Purpose: Marquette University - Valley Field Planned Development Agreement
Milwaukee Common Council File: 161712

We are requesting a minor modification to the Detailed Planned Development (DPD) known as Valley Fields to allow signage on the Seasonal Air Supported Structure (ie dome). This DPD was established by the Common Council on May 30, 2007 as file no. 070057 to permit the outdoor recreation facility, and subsequently amended on July 27, 2010 as file no. 100188 to allow construction of a new soccer team facility to the east of the existing grandstand. Most recently, a minor modification to the DPD was approved on July 2, 2013 as file no. 130371 to permit construction of new spectator seating.

Marquette University Seasonal Air Supported Structure

2 NORTH ELEVATION
SCALE : 1/16"=1'-0"

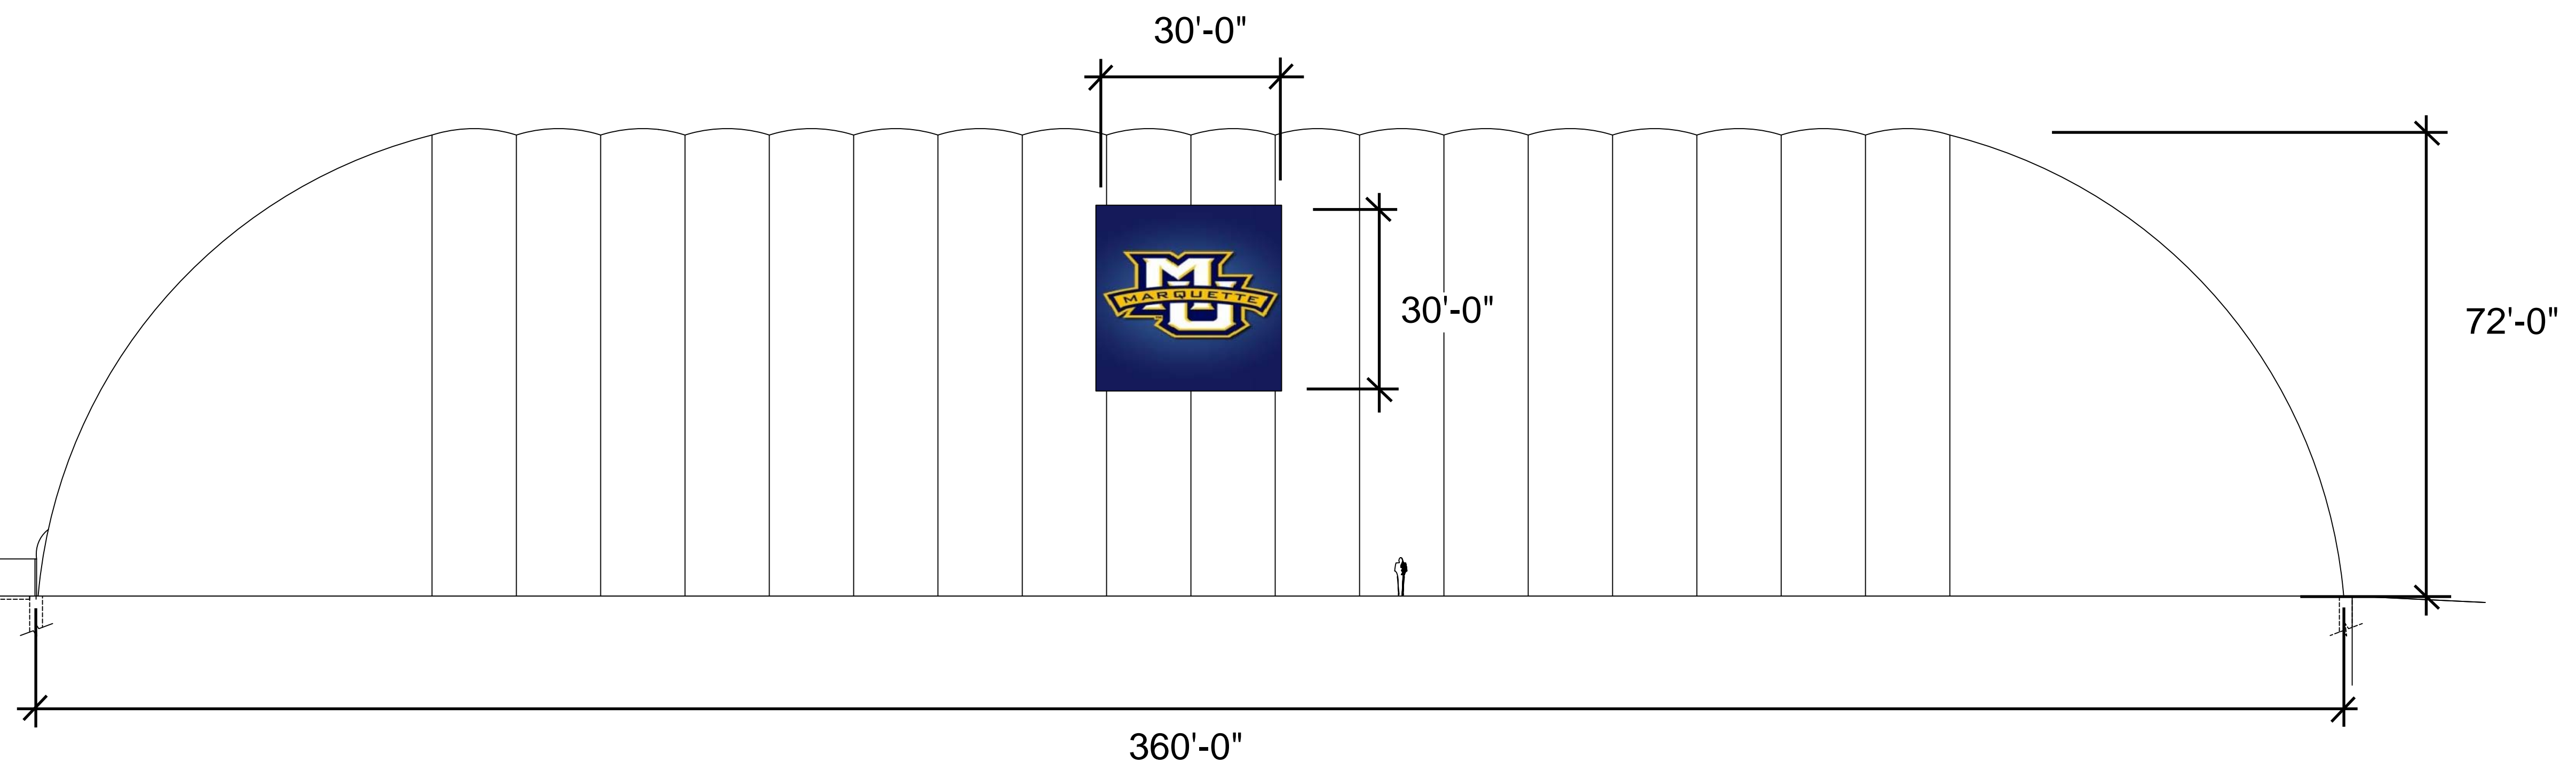
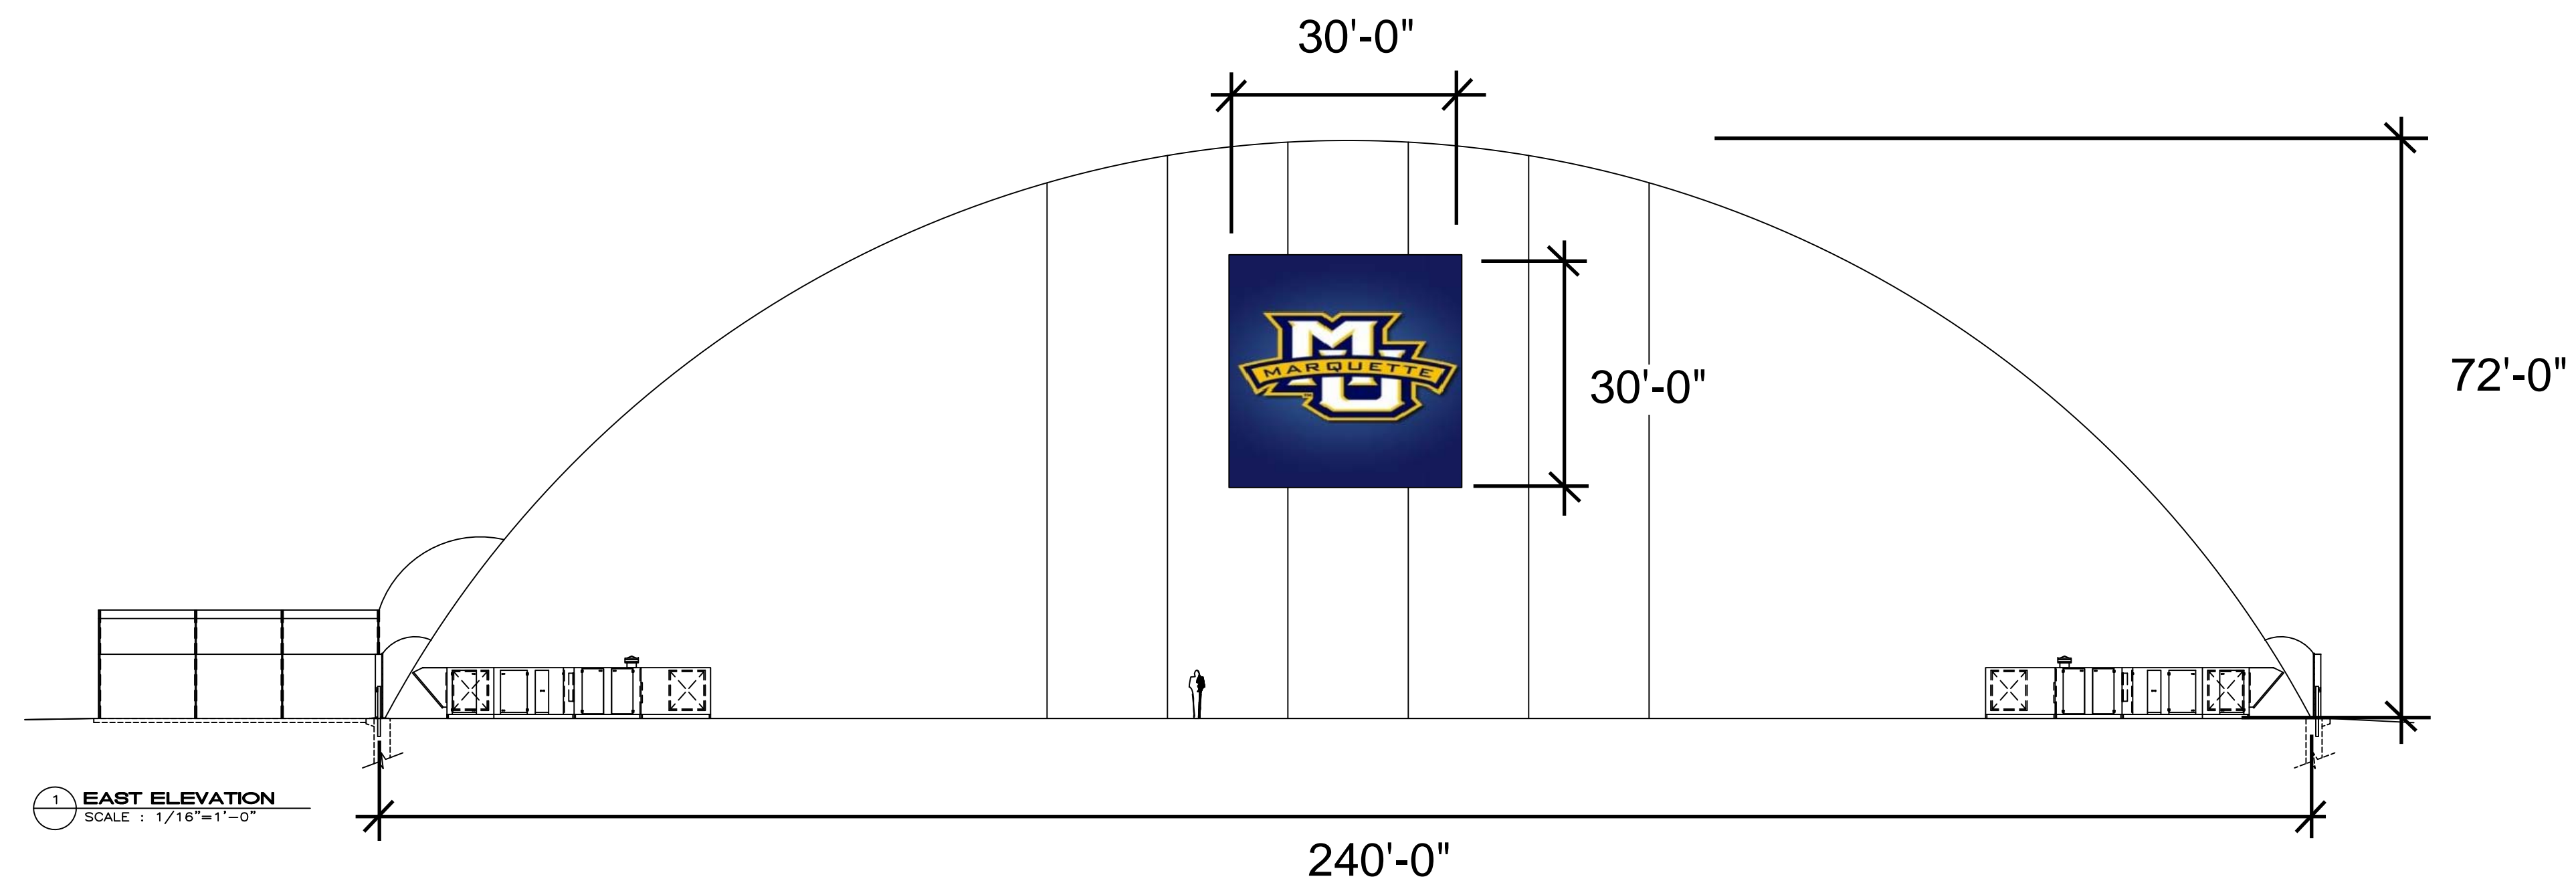
The Seasonal Air Supported Structure will be erected yearly in mid/late fall and decommissioned each spring. By code, the structure cannot be utilized for more than 180days. During this period of time, a MU-Marquette banner will be placed on the North and East elevations. The intent will be to utilize focused LED spotlights to illuminate the banners during the evening and early morning hours.

The current Planned Development Agreement for Valley Fields limits the type/size of signage and fabric banners. The manufacturer of the structure is able to provide a banner display area approximately 30feet x 30feet which can be integrated onto the exterior of the dome fabric. We

have included initial renderings of the banners for the North and East elevations noting the approximate size of the banners.
